INDEX OF SHEETS REV. 2019 01-10 JPS

PLAN OF PROPOSED IMPROVEMENT

FIRST ADDITION TO 1000 OAKS PHASE 6

CITY PROJECT NO. 11935
 CITY CONTRACT NO. 8198
 MUNIS NO. 11935

PLAN AND PROFILE
GARDEN LILY WAY CITY OF MADISON

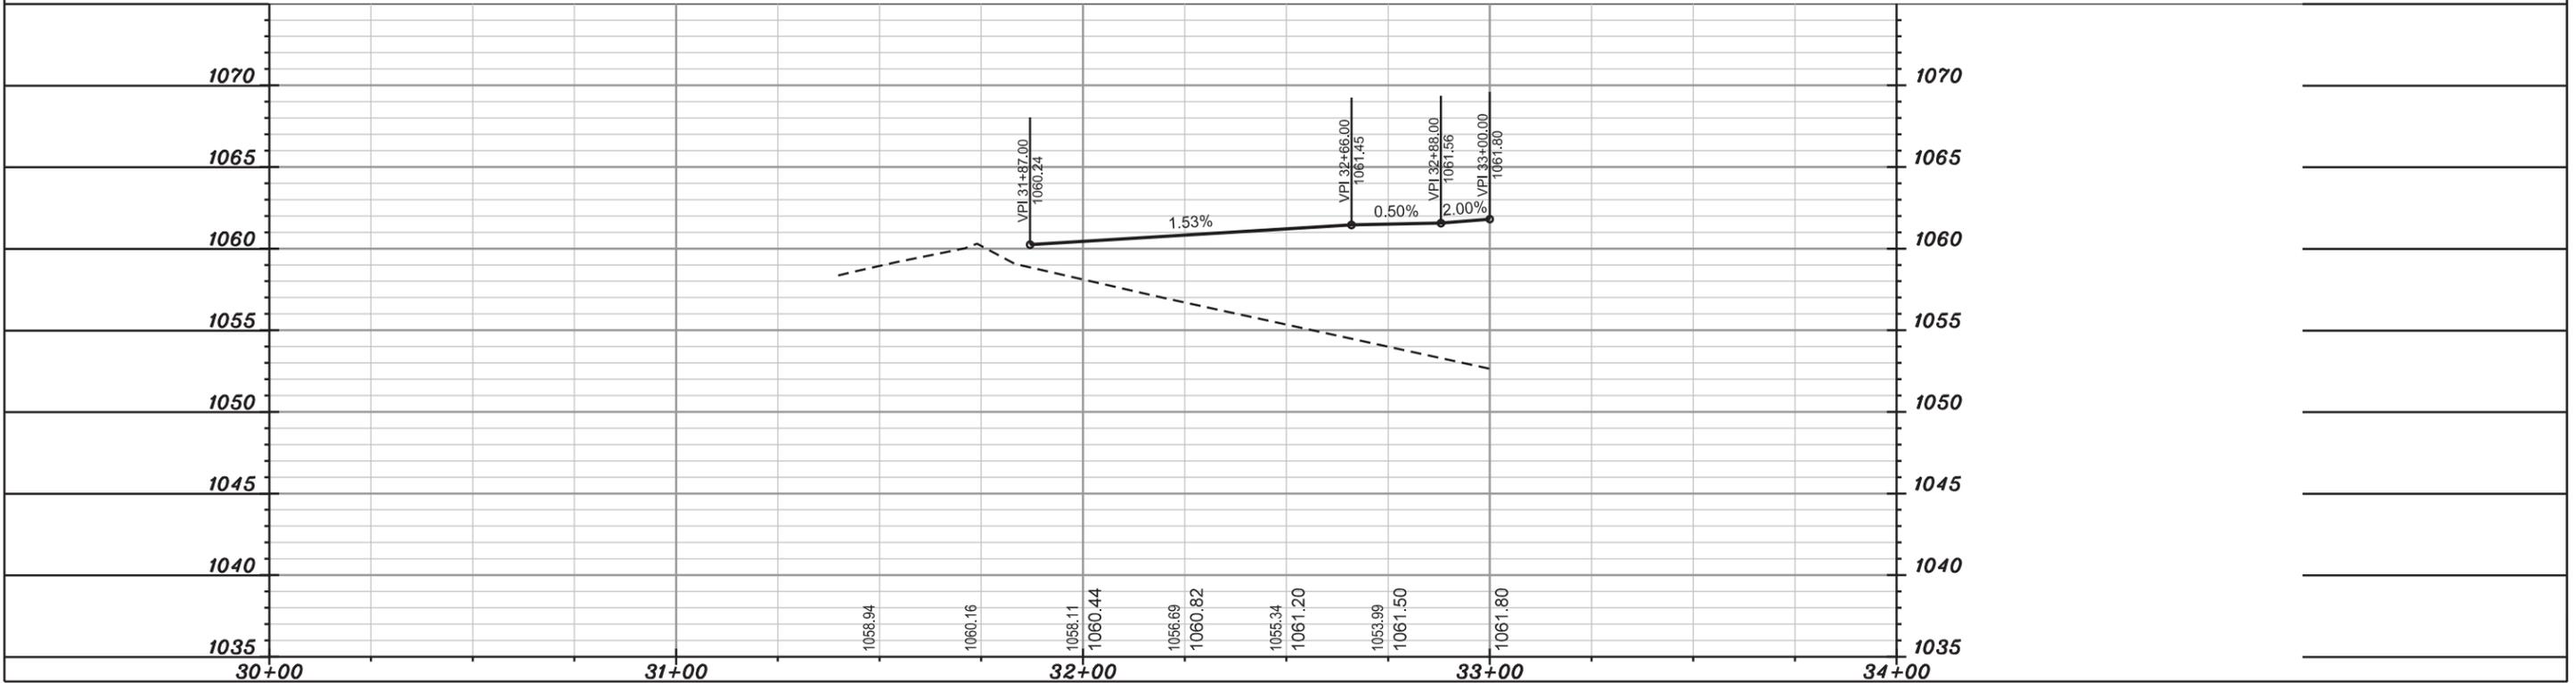
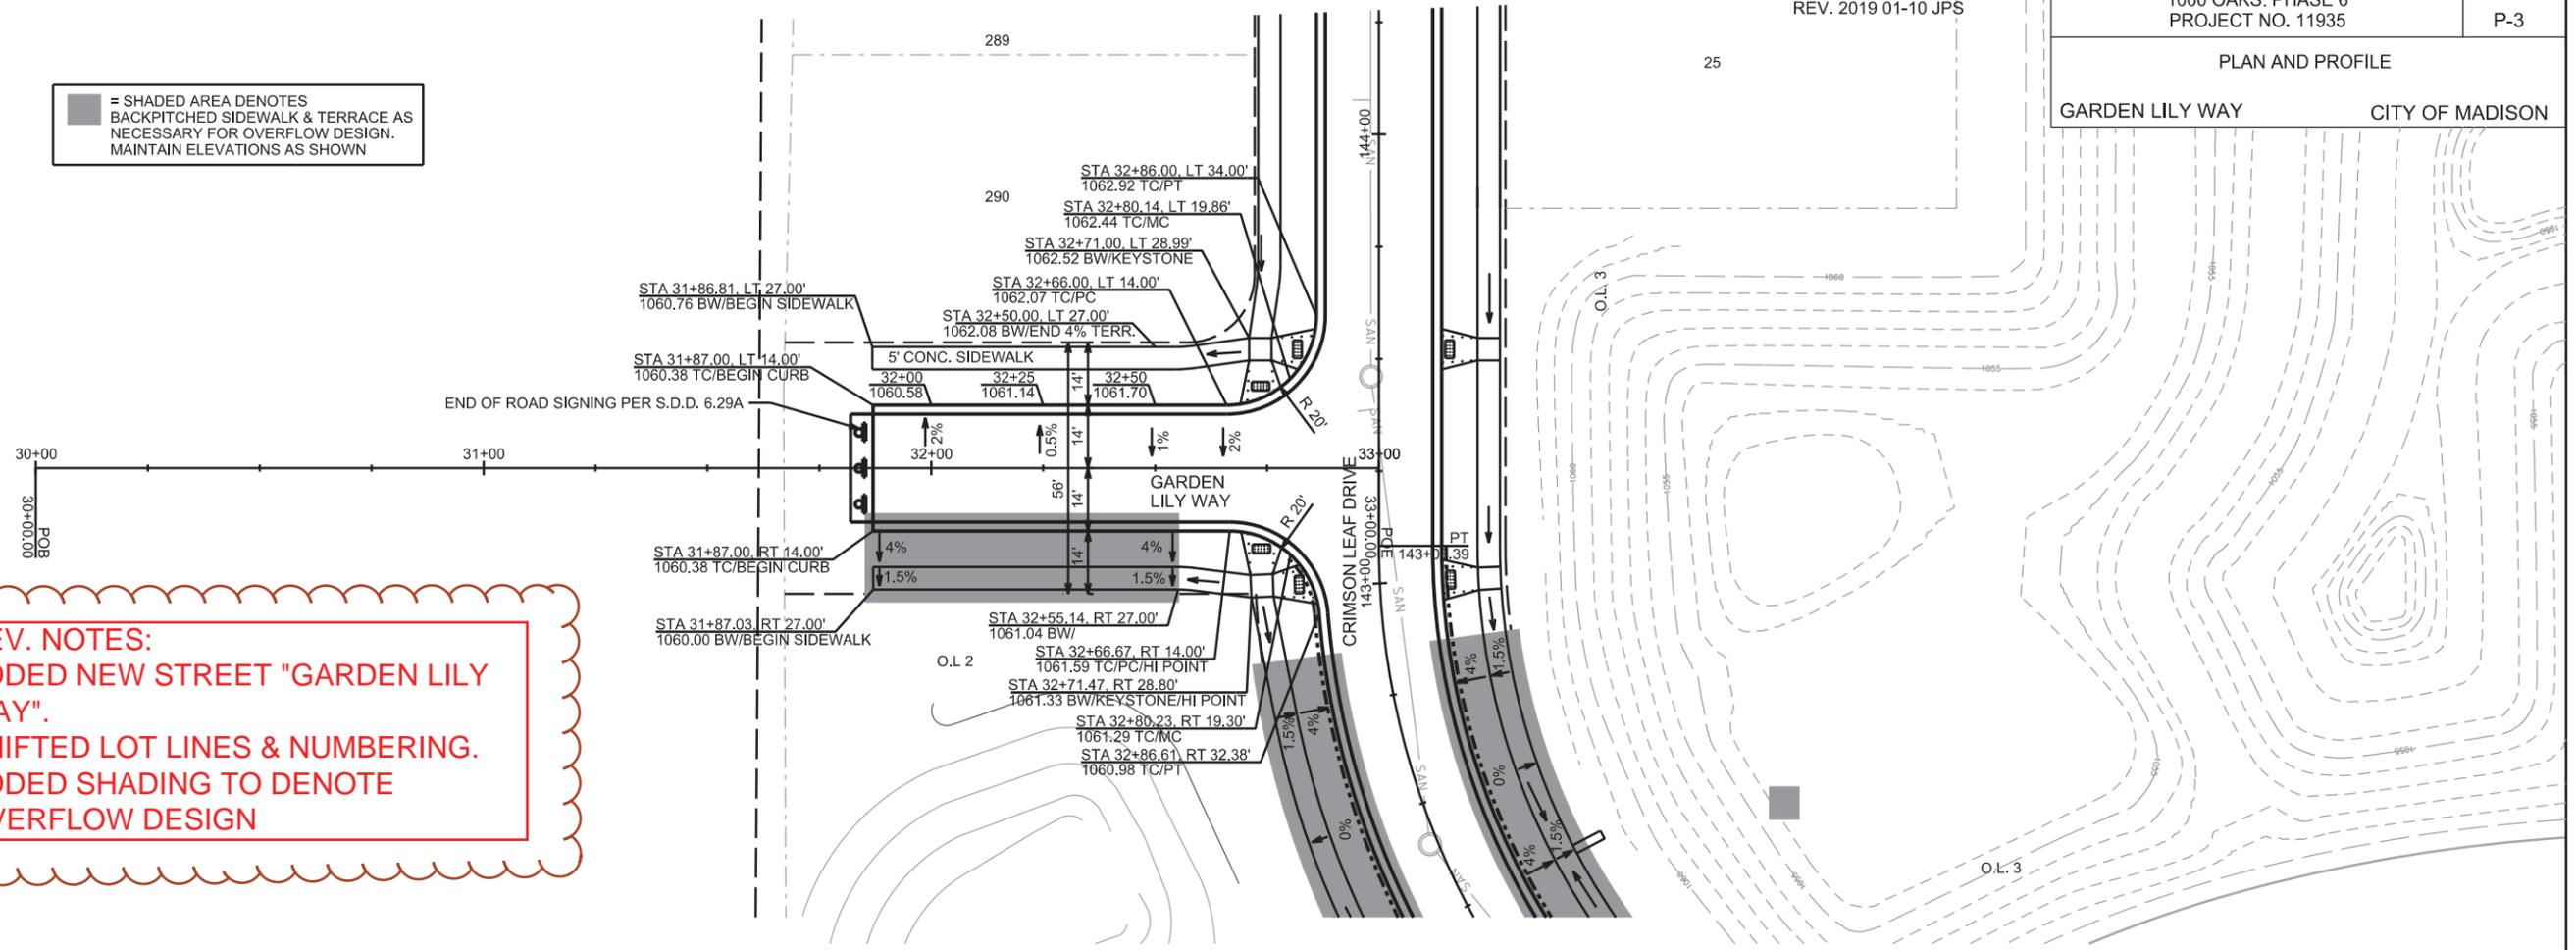
■ = SHADED AREA DENOTES
BACKPITCHED SIDEWALK & TERRACE AS
NECESSARY FOR OVERFLOW DESIGN.
MAINTAIN ELEVATIONS AS SHOWN

REV. NOTES:
ADDED NEW STREET "GARDEN LILY
WAY".
SHIFTED LOT LINES & NUMBERING.
ADDED SHADING TO DENOTE
OVERFLOW DESIGN

UTILITIES
PLAN AND PROFILE

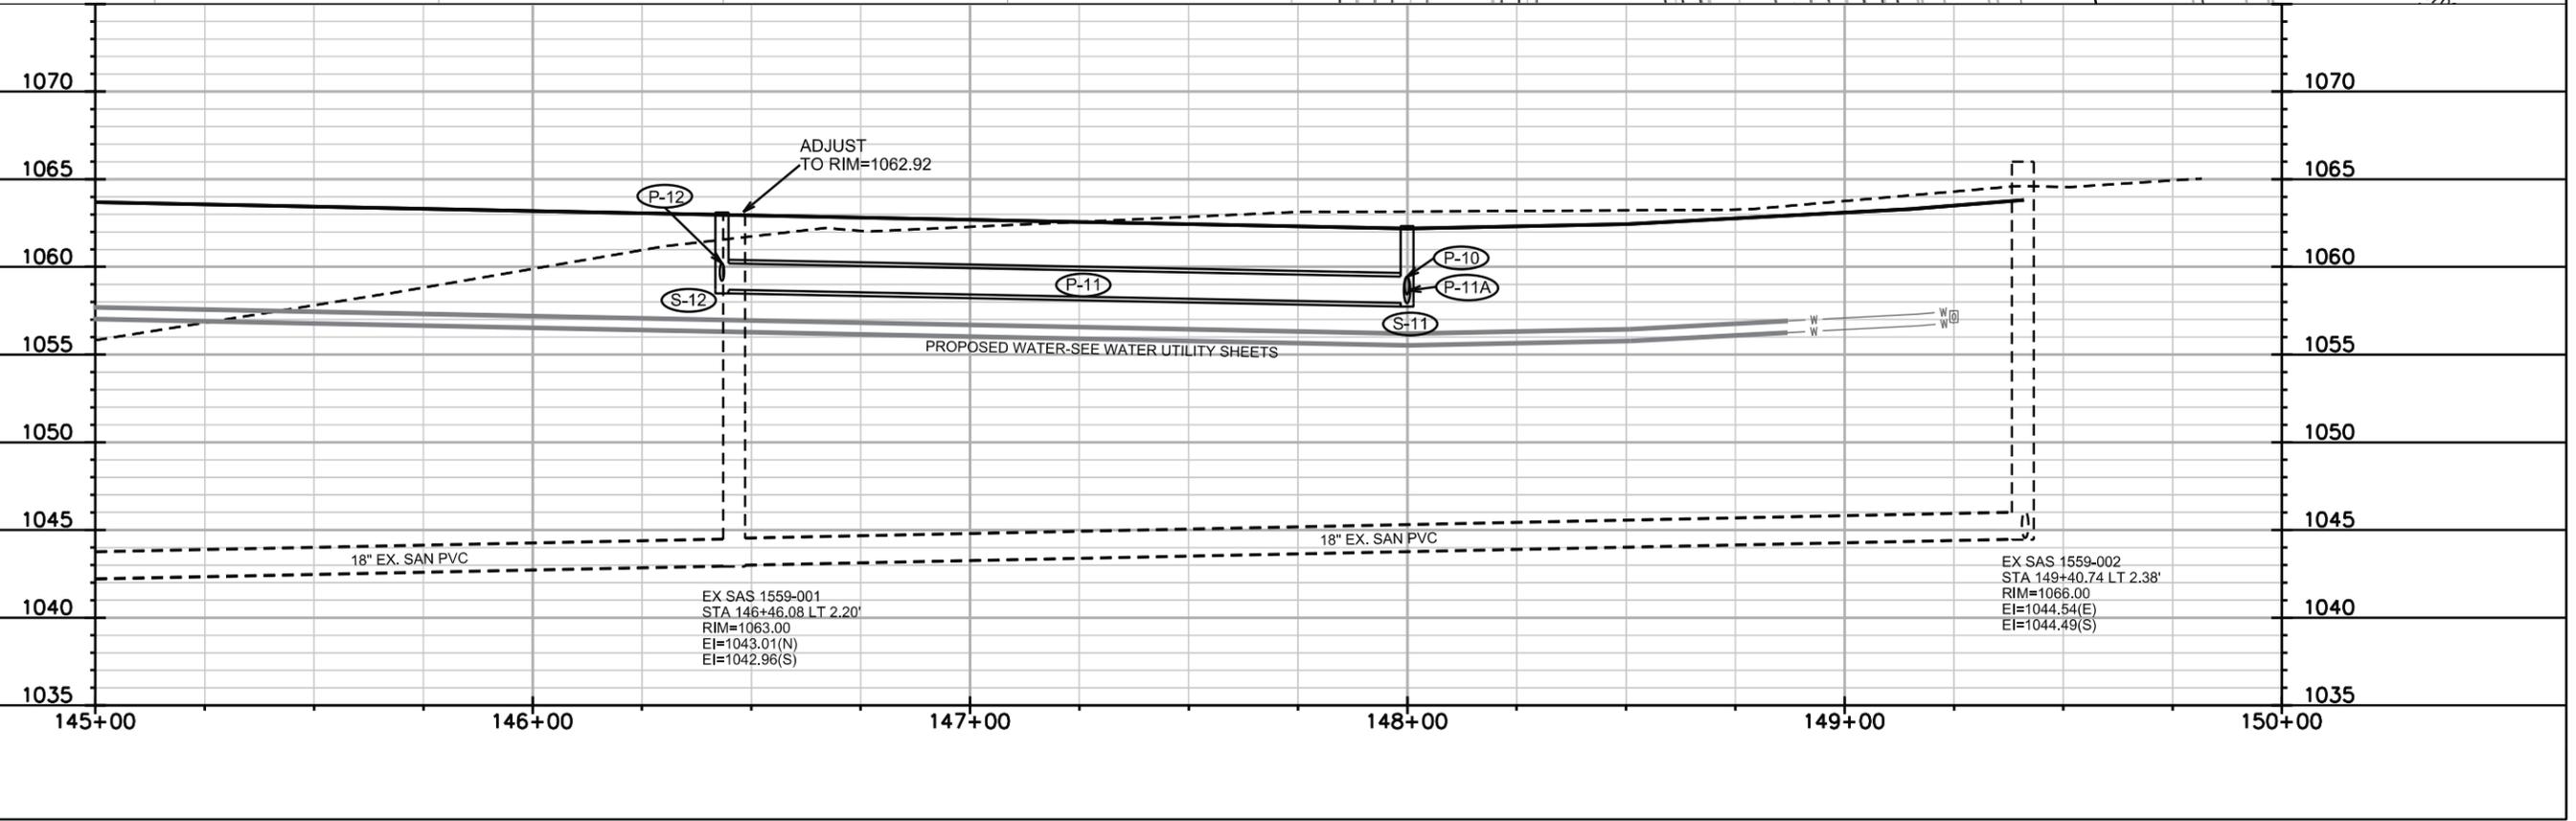
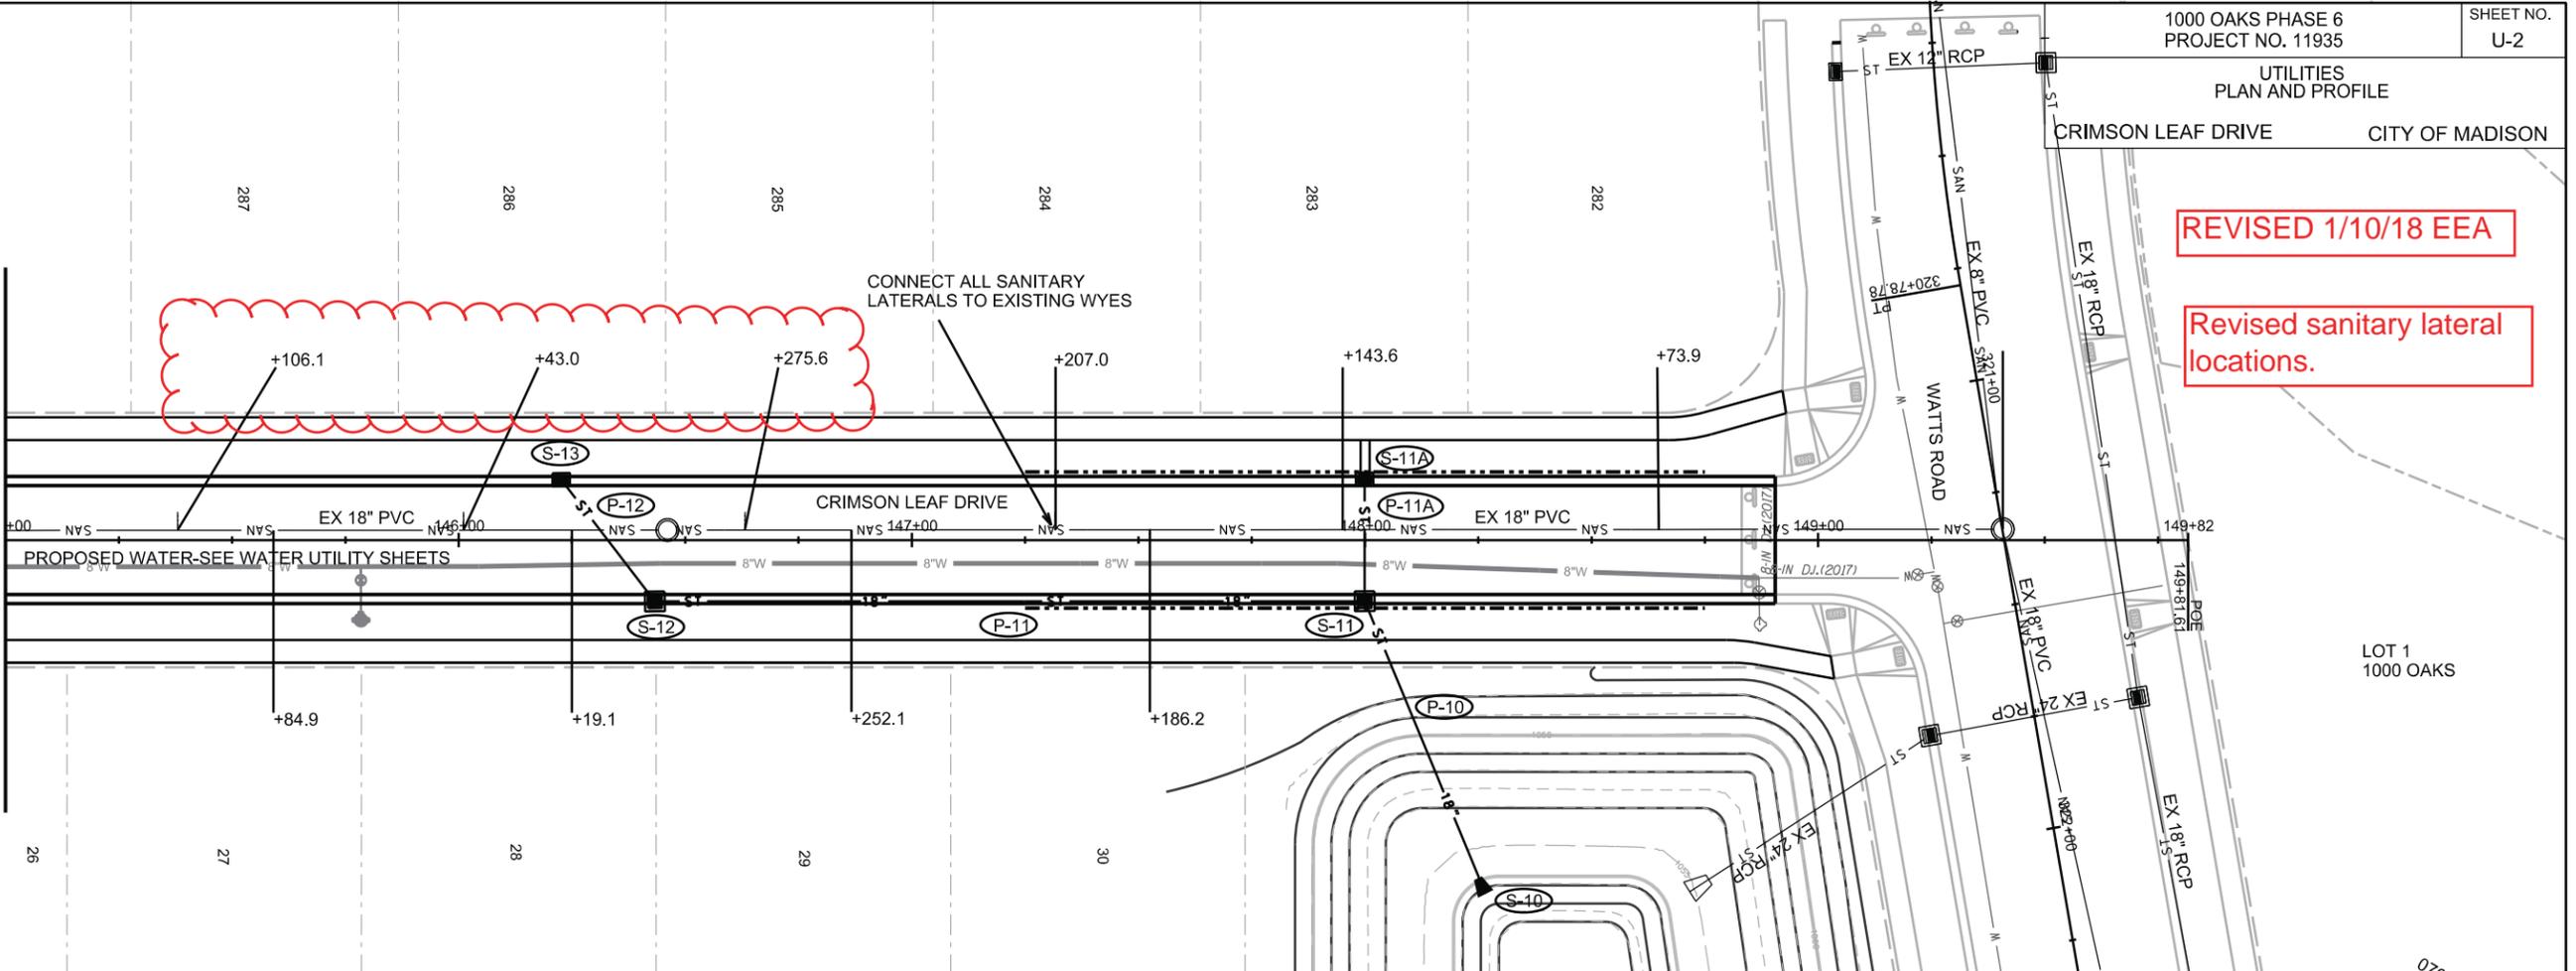
REVISED 1/10/18 EEA

Revised sanitary lateral locations.

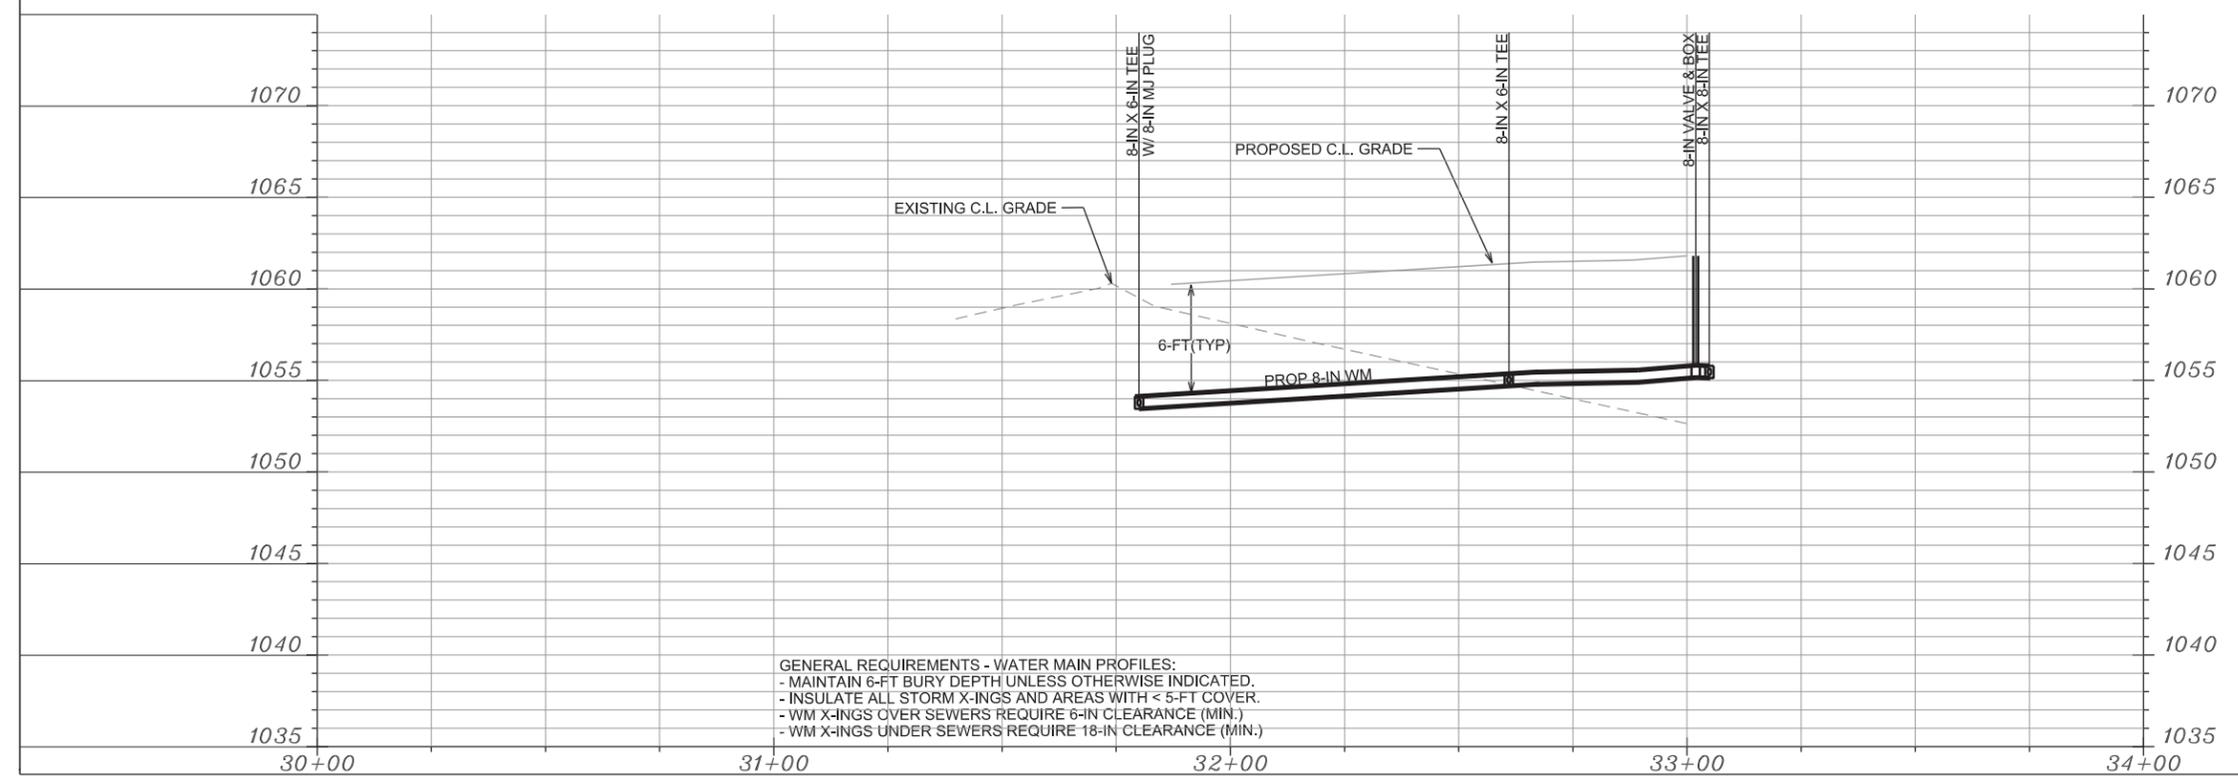
AJS 1/10/19 REV -
EXTENDED 8-IN WM PAST
PAVING LIMITS ON GARDEN
LILY WAY; ADDED HYDRANT
AT INTERSECTION WITH
CRIMSON LEAF DRIVE AND A
TEMPORARY HYDRANT AT
END OF STUB
